Re: 3008835
C&H/157 Cobey Creek/mo

The truss drawing(s) referenced below have been prepared by MiTek USA, Inc. under my direct supervision based on the parameters provided by Builders FirstSource (Valley Center).

Pages or sheets covered by this seal: I54487261 thru I54487265

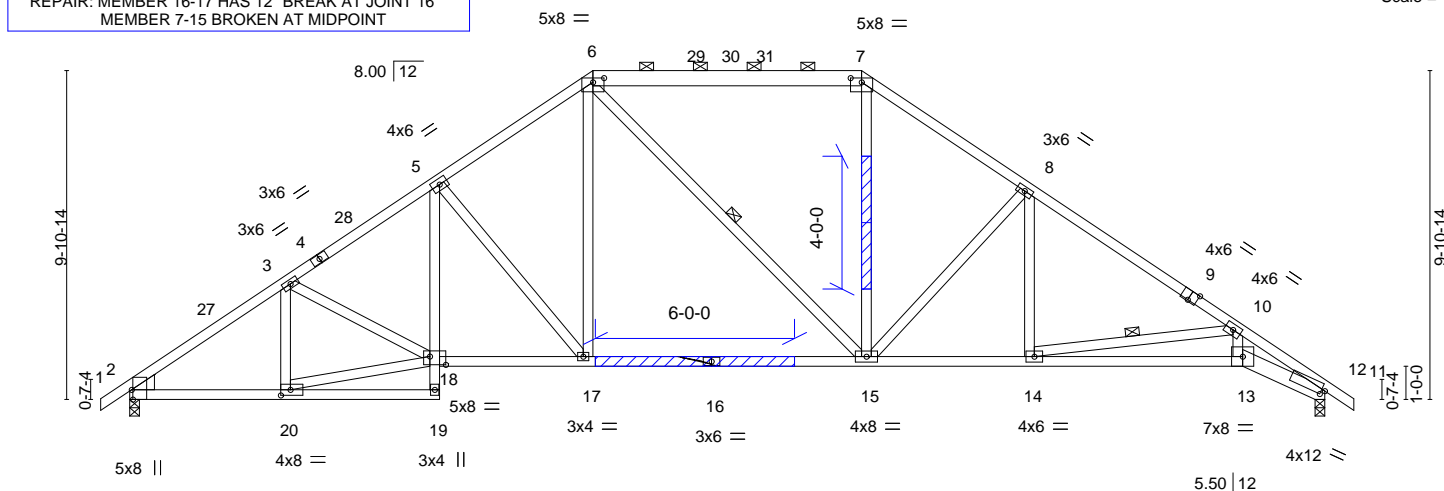
REPAIR: MEMBER 16-17 HAS 12" BREAK AT JOINT 16
 MEMBER 7-15 BROKEN AT MIDPOINT

APPLY 2 X 4 SPF NO.2 SCAB(S) TO EACH FACE OF TRUSS CENTERED ON DAMAGE AS SHOWN. ATTACH WITH (0.131" X 3") NAILS PER THE FOLLOWING NAIL SCHEDULE: 2 X 3'S - 1 ROW, 2 X 4'S - 2 ROWS, 2 X 6'S AND LARGER - 3 ROWS; SPACED @ 4" O.C. STAGGER NAIL SPACING FROM FRONT FACE AND BACK FACE FOR A NET 2" O.C SPACING IN THE TRUSS. USE 2" MEMBER END DISTANCE.

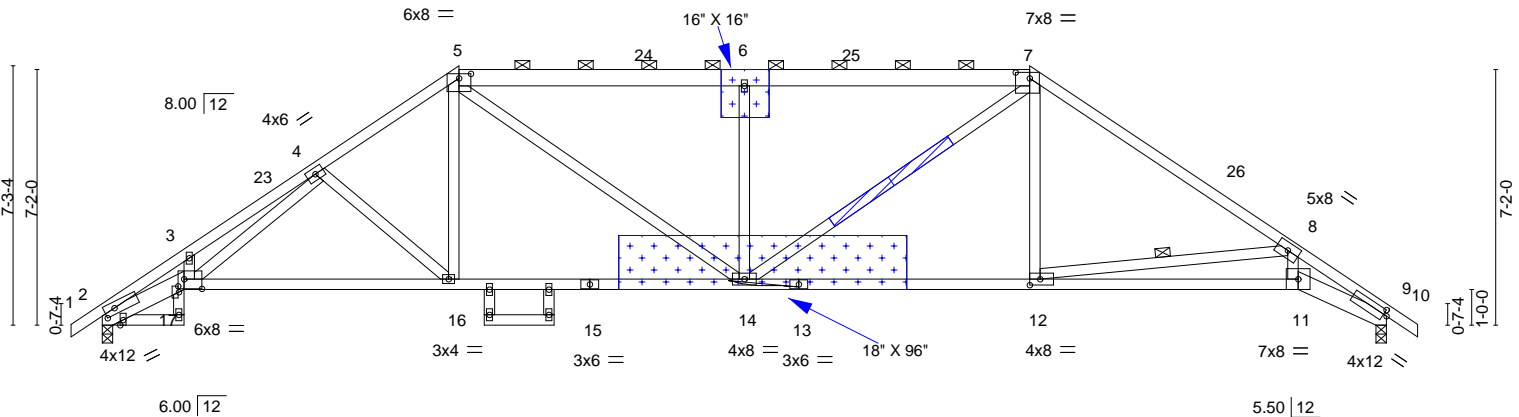
REPAIR: PLATES LOOSE AT JOINT 6
MEMBER 7-14 BROKEN AT MIDPOINT
BOTTOM CHORD 13-15 HAS 24" BREAK STARTING AT JOINT 13

ATTACH 1/2" PLYWOOD OR OSB GUSSET (15/32" RATED SHEATHING 32/16 EXP 1)
TO EACH FACE OF TRUSS WITH (0.131" X 2.5" MIN.) NAILS PER THE FOLLOWING NAIL SCHEDULE:
2 X 3'S - 2 ROWS, 2 X 4'S - 3 ROWS, 2 X 6'S AND LARGER - 4 ROWS: SPACED @ 4" O.C.
NAILS TO BE DRIVEN FROM BOTH FACES. STAGGER SPACING FROM FRONT TO BACK FACE
FOR A NET 2" O.C. SPACING IN EACH COVERED TRUSS MEMBER. USE 2" MEMBER END DISTANCE.

APPLY 2 X 4 X 4' SPF NO.2 SCAB(S) TO EACH FACE OF TRUSS CENTERED
ON DAMAGE. ATTACH WITH (0.131" X 3") NAILS PER THE FOLLOWING NAIL
SCHEDULE: 2 X 3'S - 1 ROW, 2 X 4'S - 2 ROWS, 2 X 6'S AND LARGER - 3 ROWS:
SPACED @ 4" O.C. STAGGER NAIL SPACING FROM FRONT FACE AND BACK FACE
FOR A NET 2" O.C. SPACING IN THE TRUSS. USE 2" MEMBER END DISTANCE.

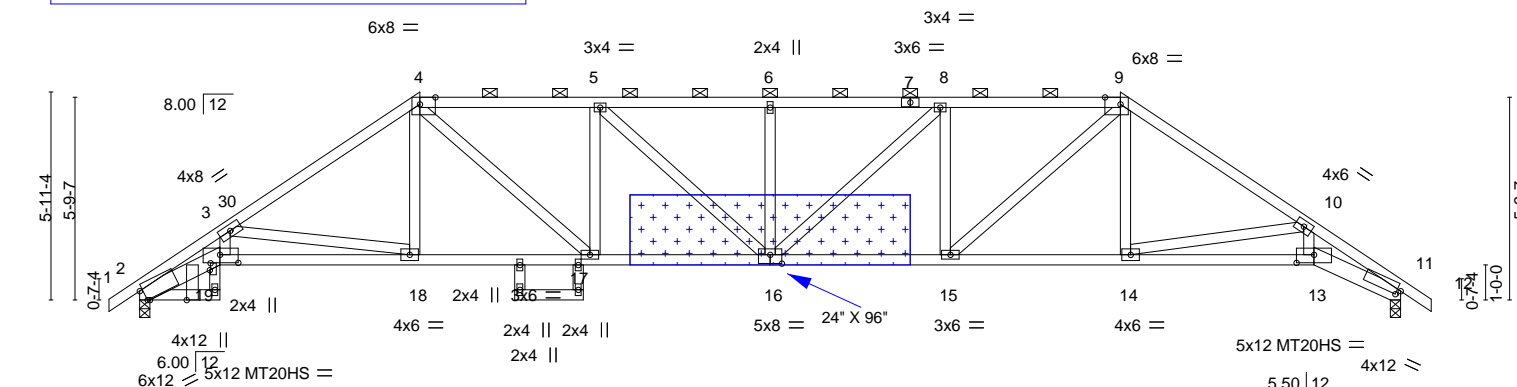
REPAIR: MEMBER 8-16 HAS 6" BREAK AT JOINT 16

ATTACH 1/2" PLYWOOD OR OSB GUSSET (15/32" RATED SHEATHING 32/16 EXP 1)
TO EACH FACE OF TRUSS WITH (0.131" X 2.5" MIN.) NAILS PER THE FOLLOWING NAIL SCHEDULE:
2 X 3'S - 2 ROWS, 2 X 4'S - 3 ROWS, 2 X 6'S AND LARGER - 4 ROWS: SPACED @ 4" O.C.
NAILS TO BE DRIVEN FROM BOTH FACES. STAGGER SPACING FROM FRONT TO BACK FACE
FOR A NET 2" O.C. SPACING IN EACH COVERED TRUSS MEMBER. USE 2" MEMBER END DISTANCE.
